NEOJIBA Renovation in Parque do Queimado

Acoustical Design Report

March 28, 2016

Part 4:
Comments on Issued Drawings

Review of Drawings, 2015-11-20

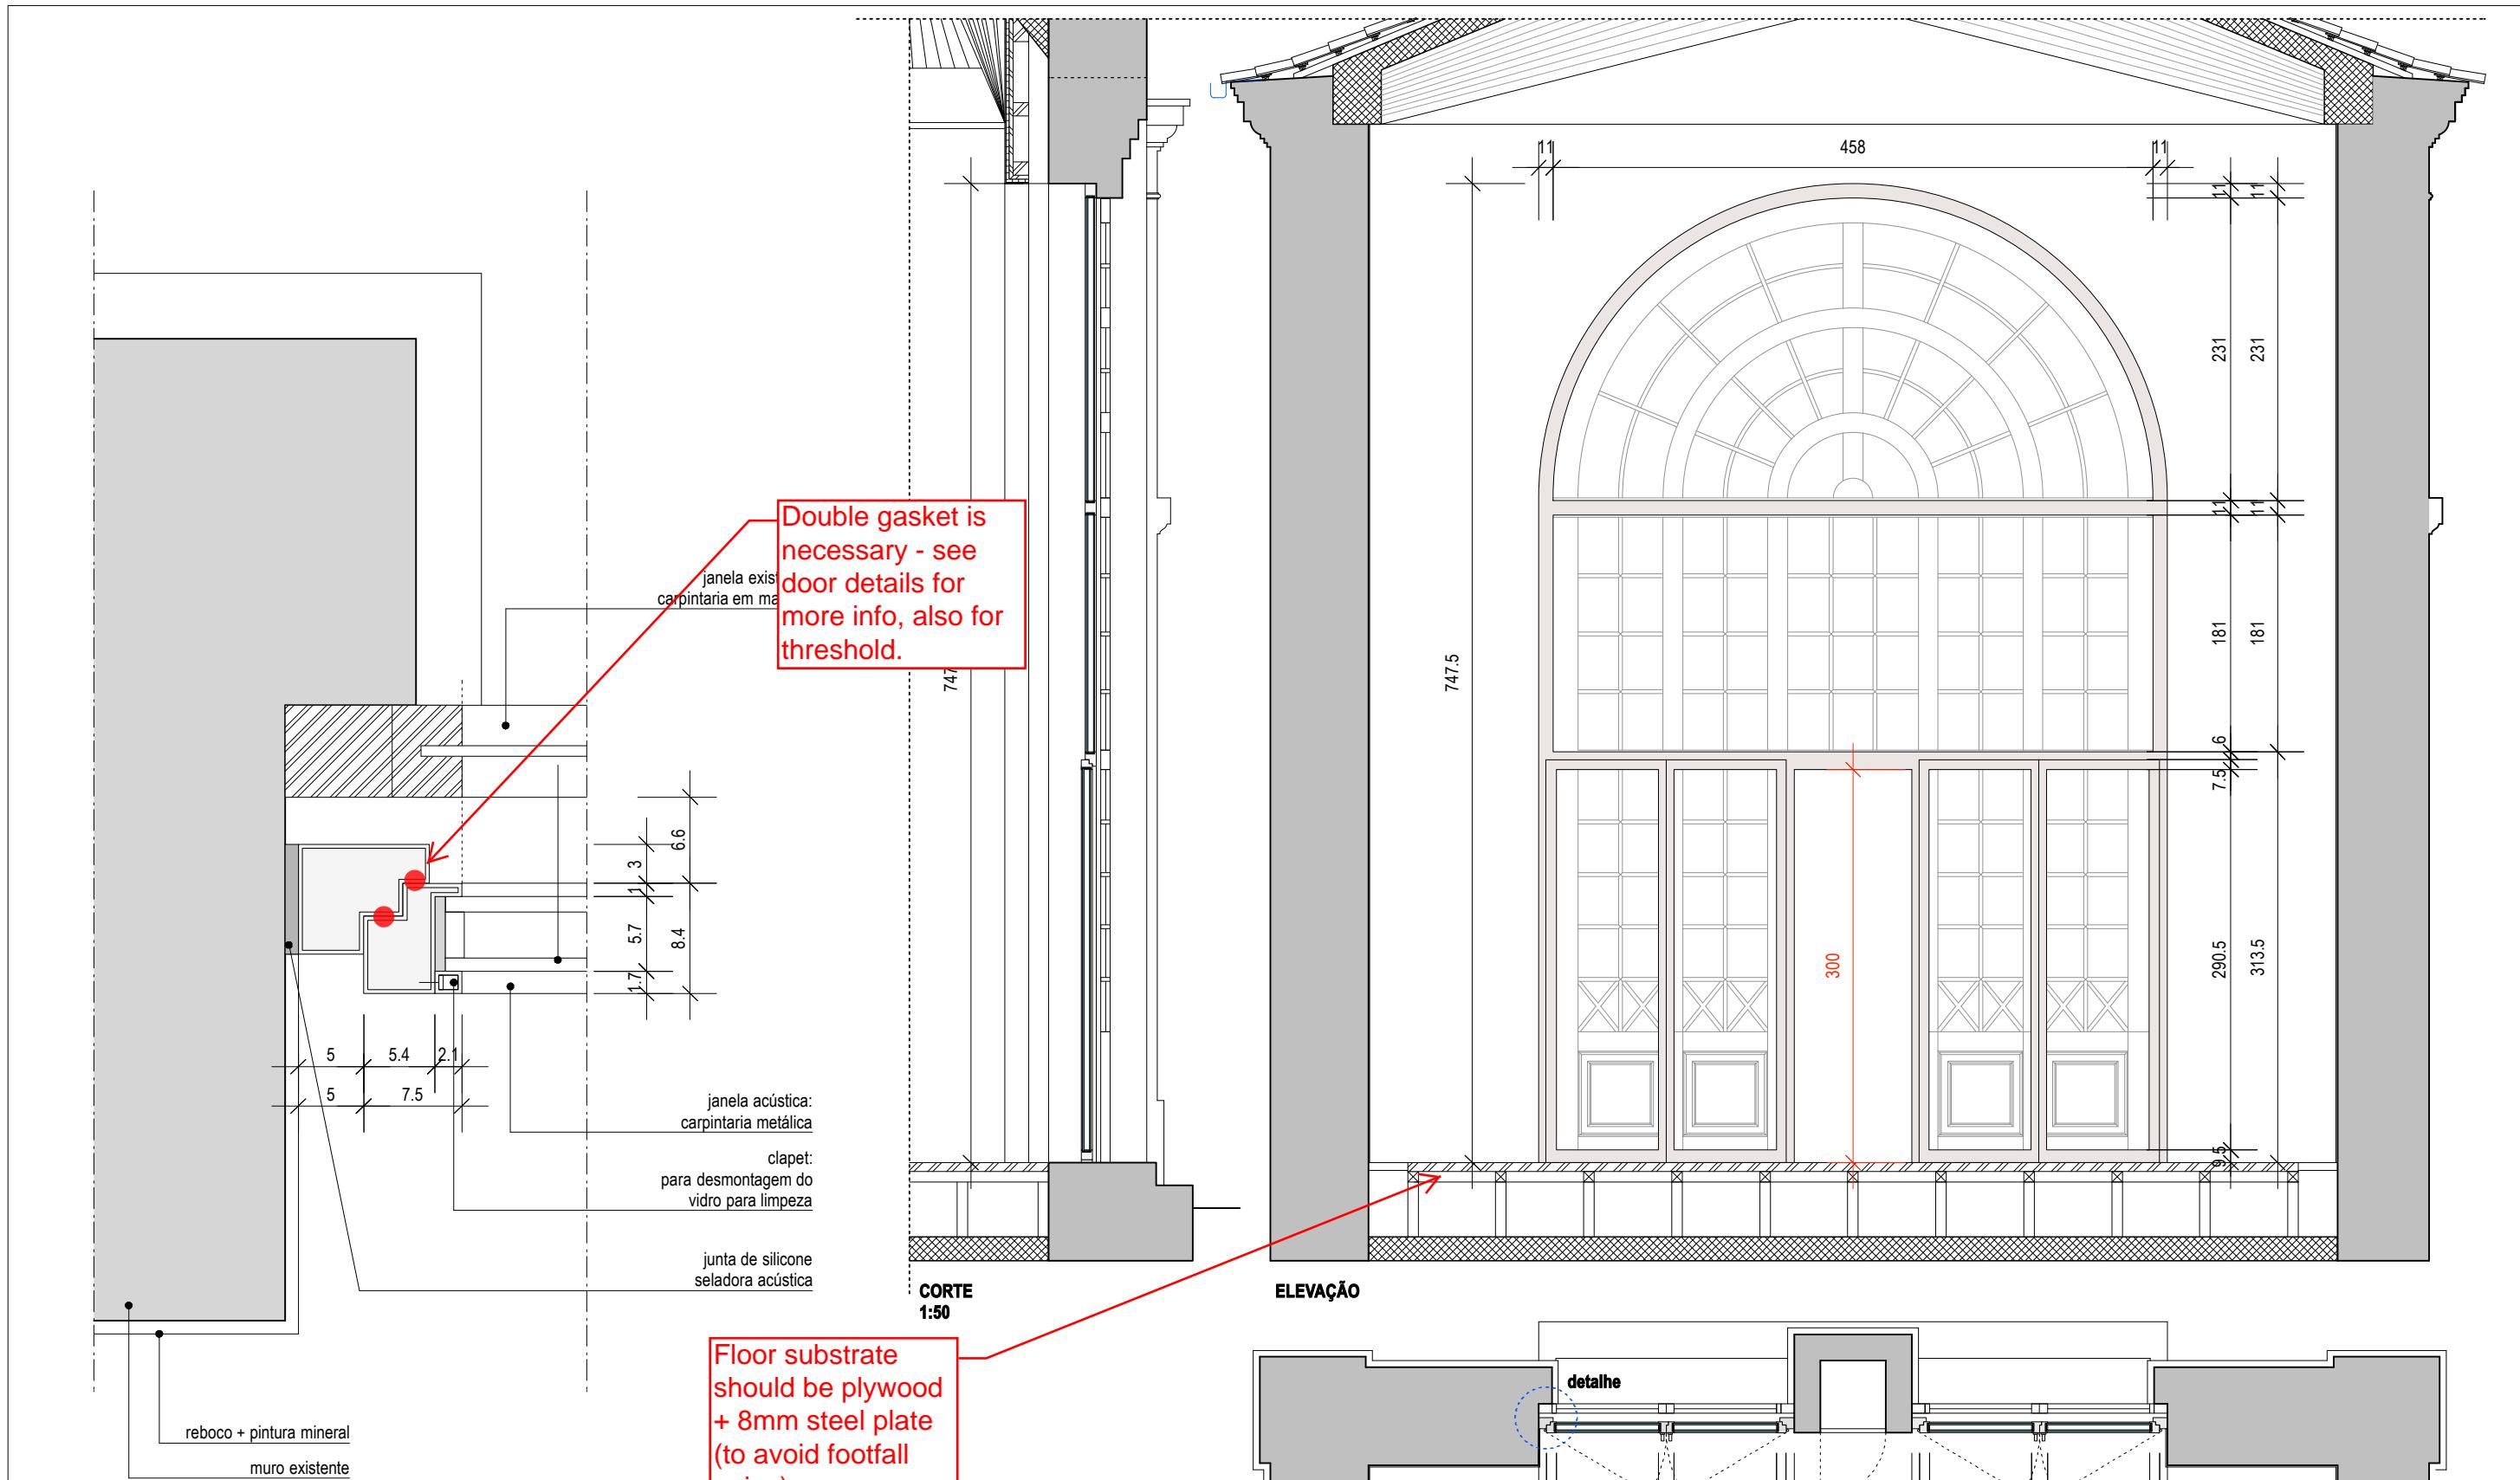
Nagata Acoustics (DB)
comments, 2015-11-20

PLANTA TÉRREO
1:50

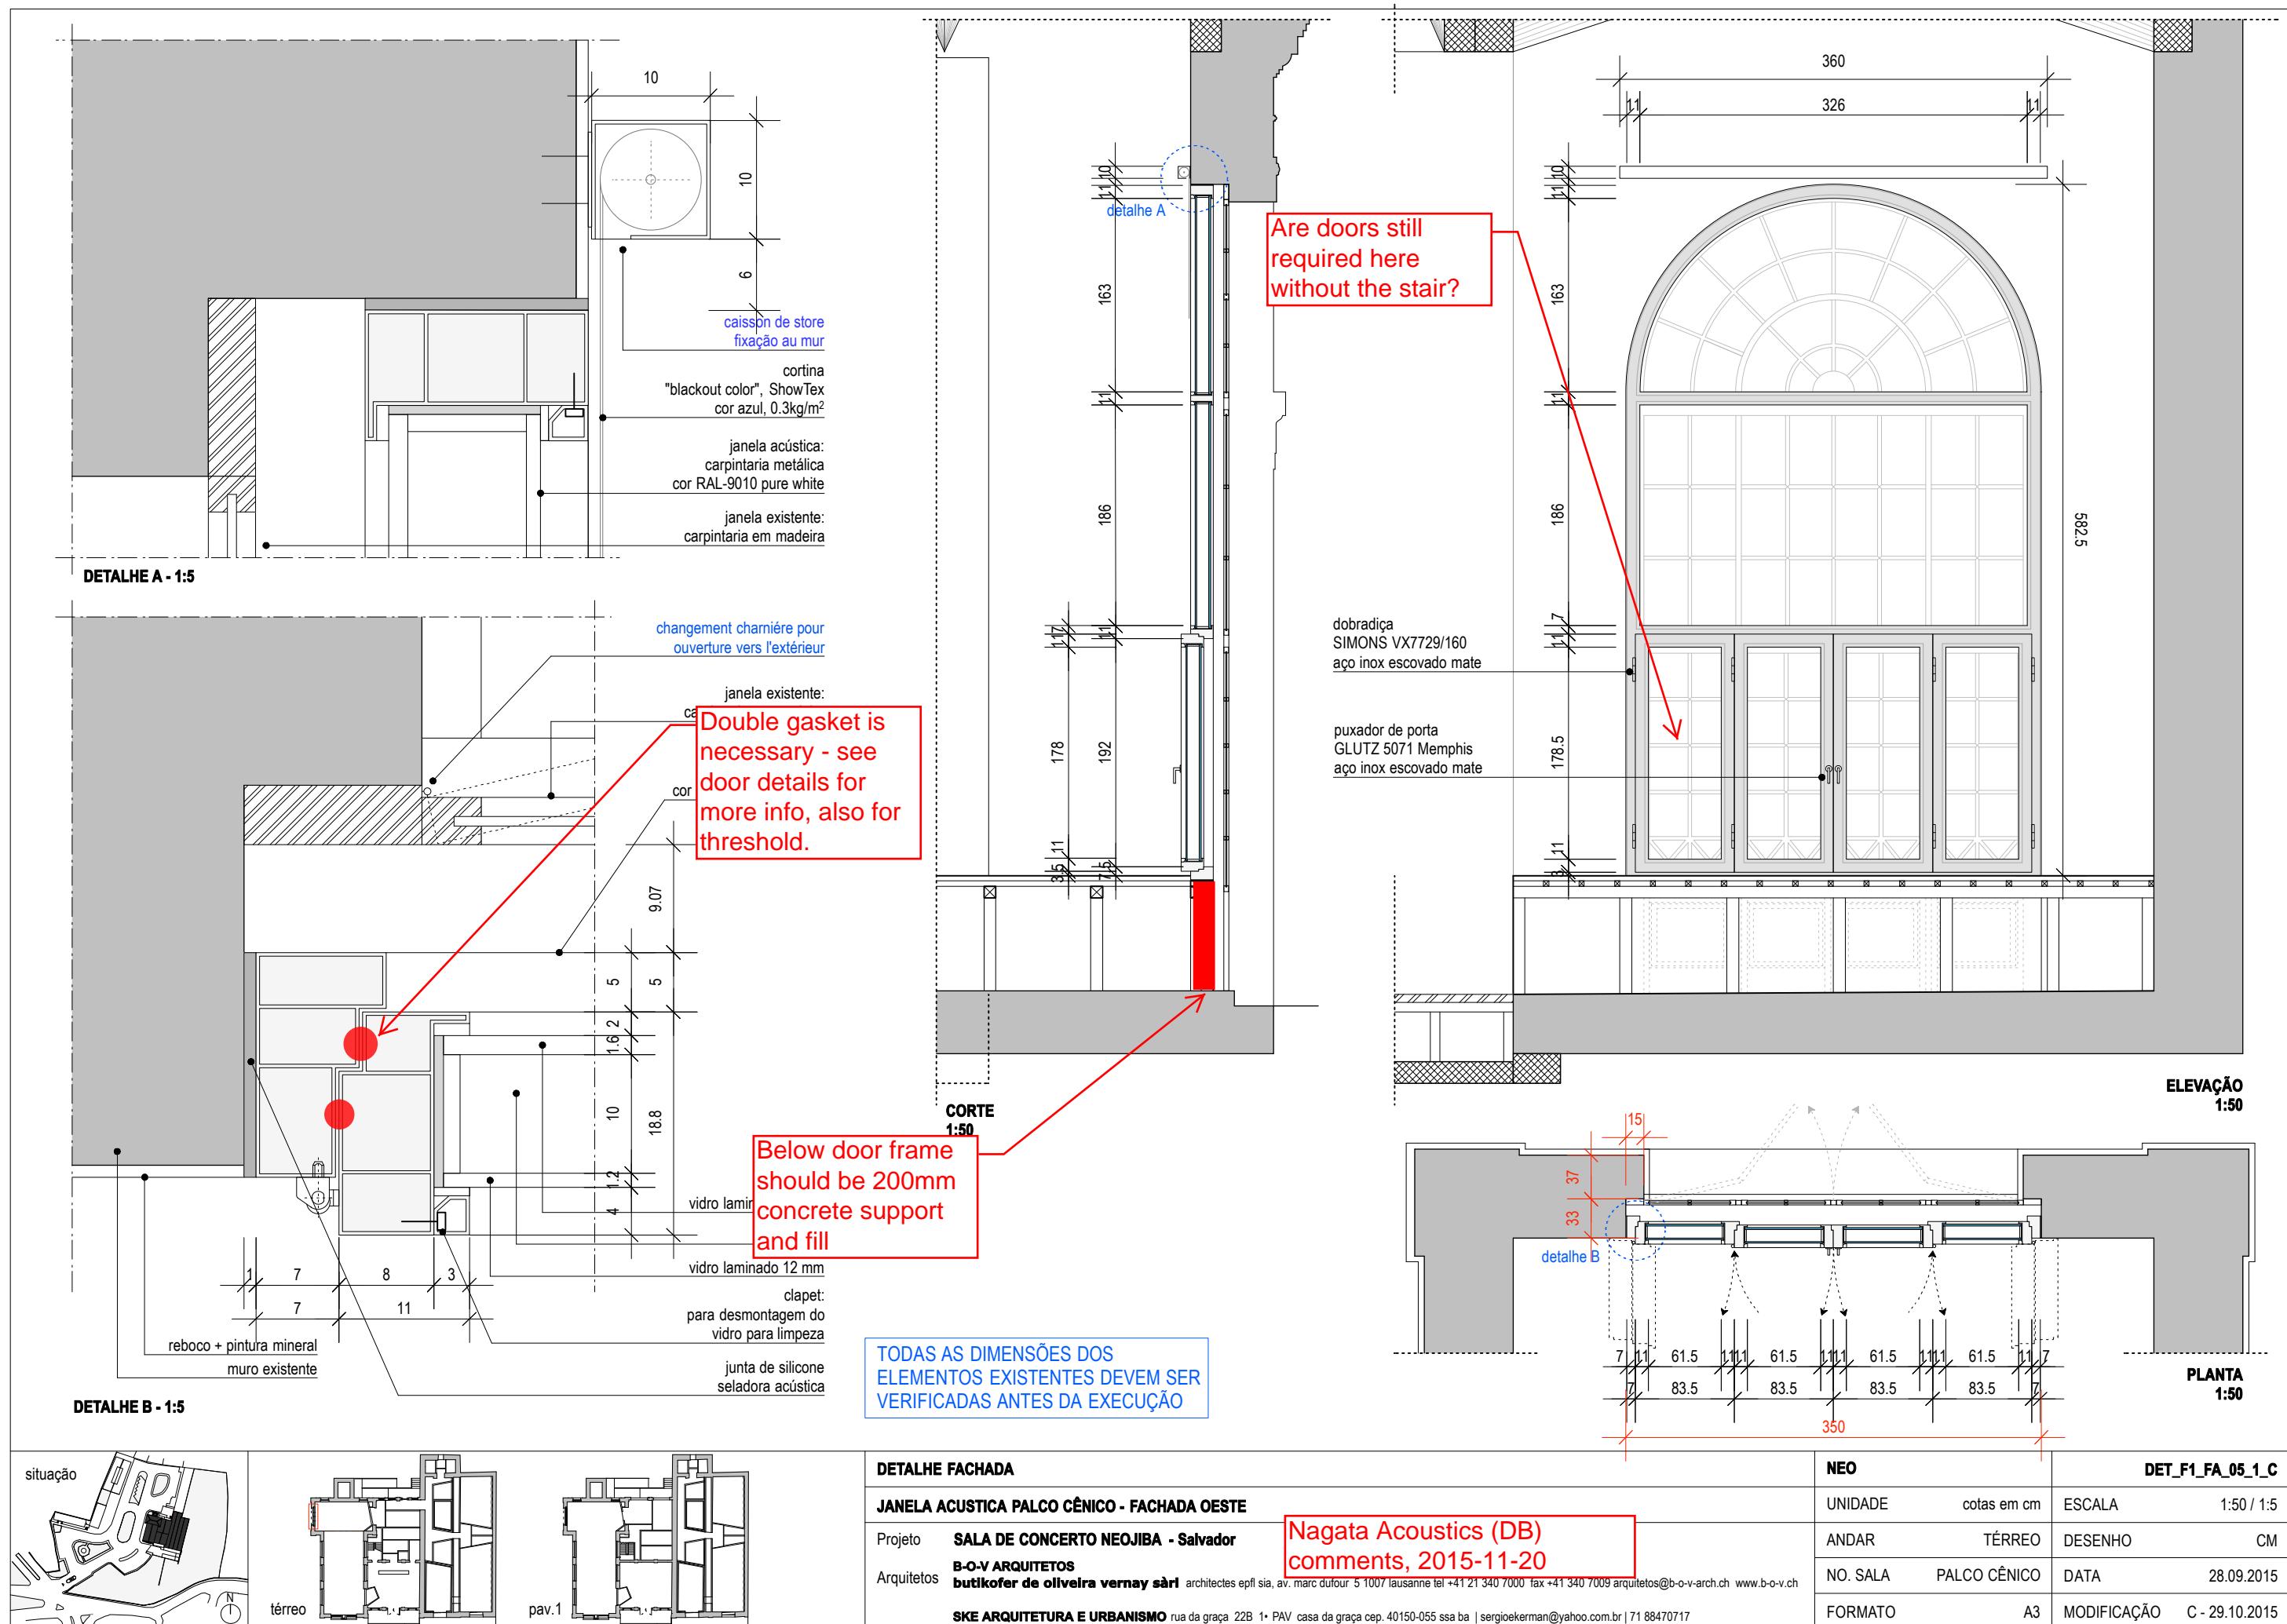
neo - SALA DE CONCERTOS NEOJIBA
Nagata Acoustics (DB)
comments, 2015-11-20

**CORTE AA - CORTE GG
1:50**

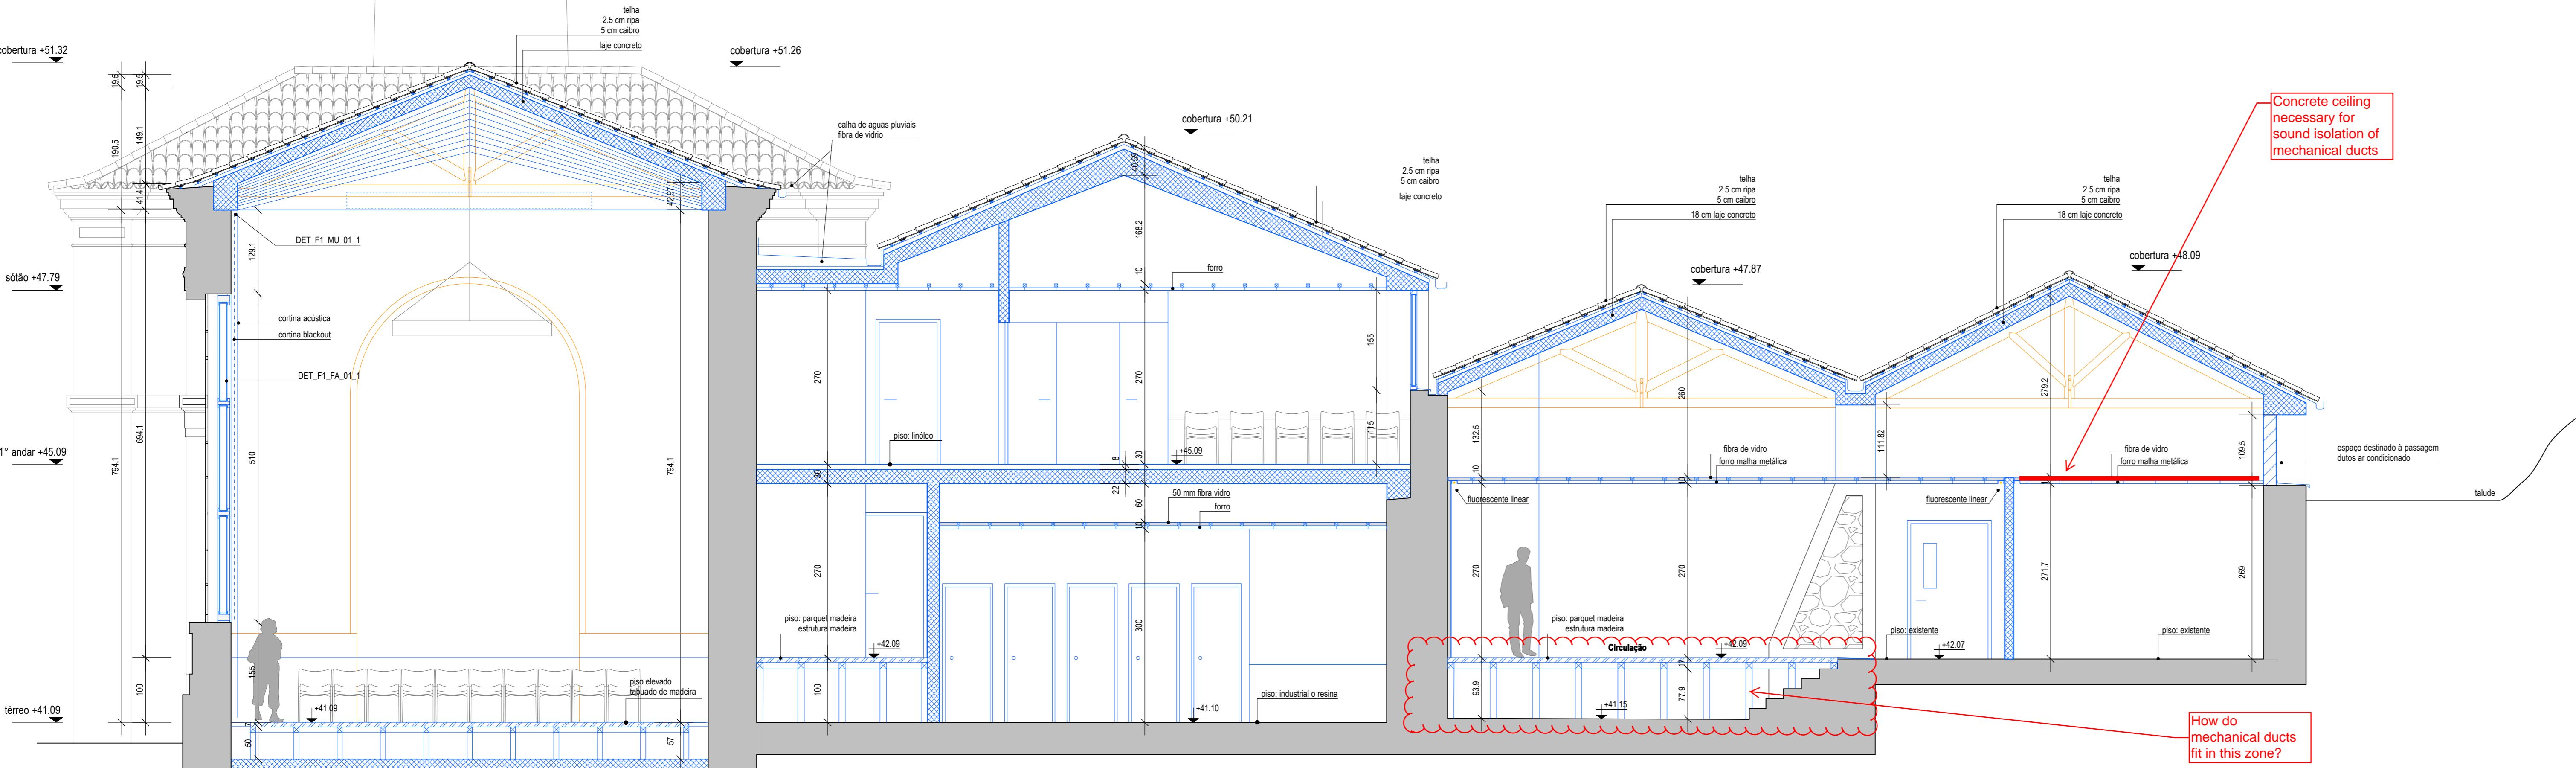
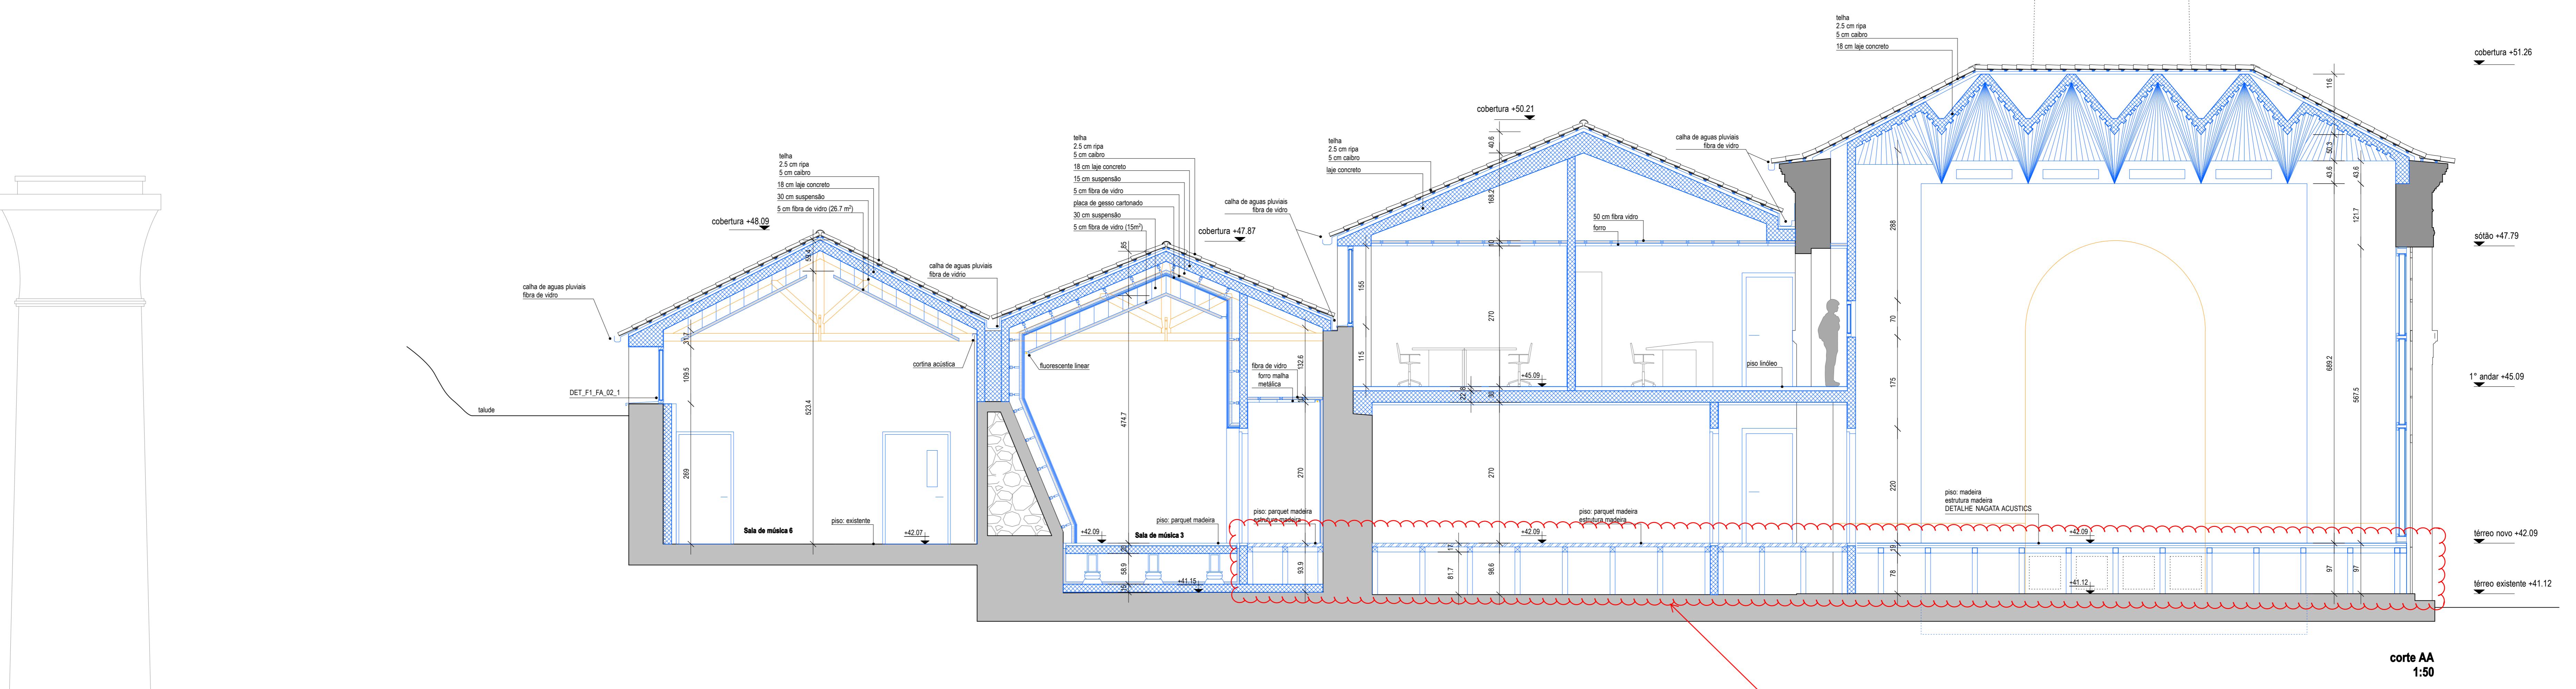
ata Acoustics (DB)
ments, 2015-11-20
